Morse (J2A) duty cycle ratings for Codan transceivers

SUBJECT: X-2 Software Release

Replacement of power transistors SRFH1008 and MRF455

Figure 1: Power amplifier PCB for the 93xx series/9780 and LP transceivers

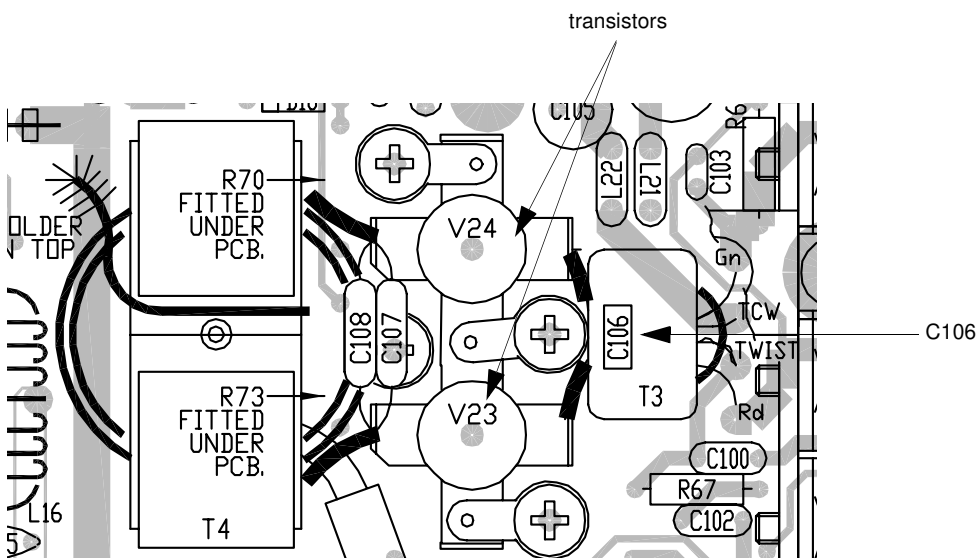
- Remove the two faulty transistors from the PA PCB (see Figure 1).

- Replace C106 with a capacitor that has a value of 470 pf.

Later model 93xx series/9780 PAs (Codan part number 08-04963-xxx) may already have the 470 pf capacitor in place. If you are unsure of the value of C106, it is recommended you replace it with a 470 pf capacitor as a precaution.

- Replace the transistors with MS1253-CDN.
- Continue from [page 3, Adjusting the driver bias for power amplifiers in 93xx series/9780 and LP transceivers.](#)

Figure 2: Power amplifier PCB for the 85xx series/9313/9480 transceivers

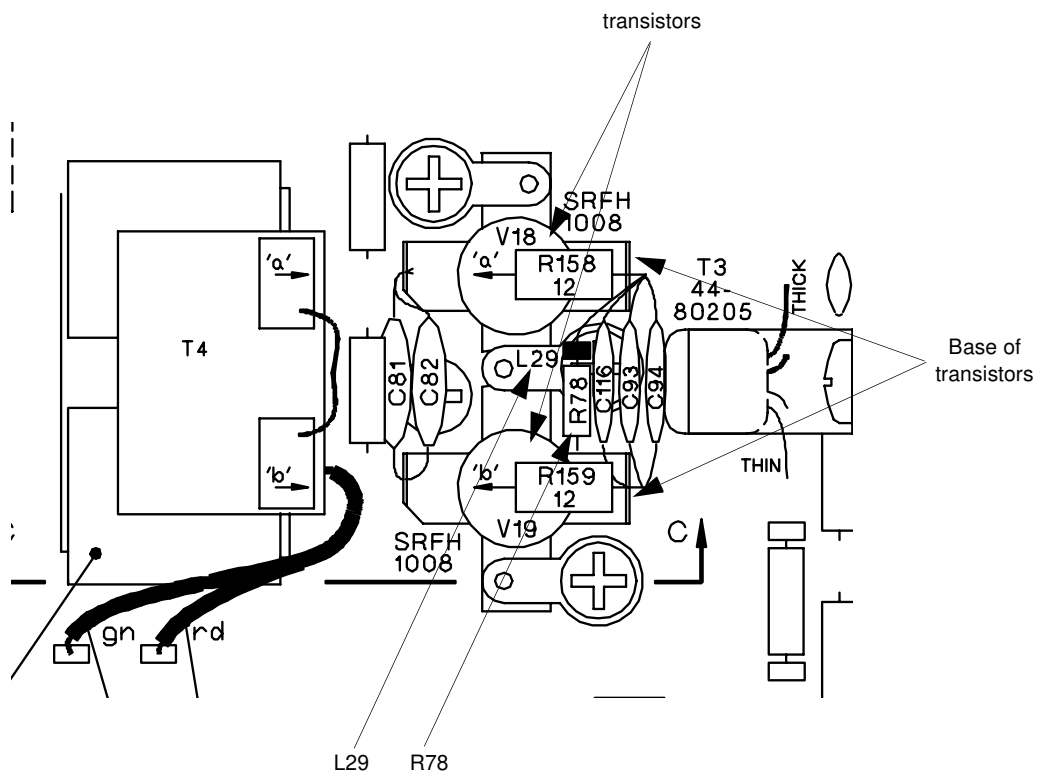
- Check if there is a resistor/choke (R78/L29) across the base of both transistors on the PA PCB (Codan part number 08-03743-xxx) (see Figure 2).

If R78/L29 is not present, it must be fitted.

Without the resistor/choke in place, spurious oscillations at approximately 4 MHz occur. The resistor/choke network consists of a:

- ↪ • 12 Ω ¼ W 5% resistor
- ferrite bead placed on one leg of the resistor with a small amount of silastic to stop any movement

- Replace the transistors with MS1253-CDN (see Figure 2).
- Continue from [page 5, Adjusting the output bias in all transceivers](#).

Figure 3: Replacing the fuse

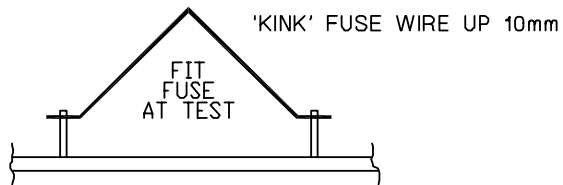
- If the **PA O/P** fuse is broken, do the following:
 - Replace the **PA O/P** fuse with two strands (2×0.2 mm TCW) taken from a piece of 7×0.2 mm cable.
 - Solder the wire ends to the stakes as shown in [Figure 3](#).
 - Kink the wire up 10 mm to form an inverted V as shown in [Figure 3](#).
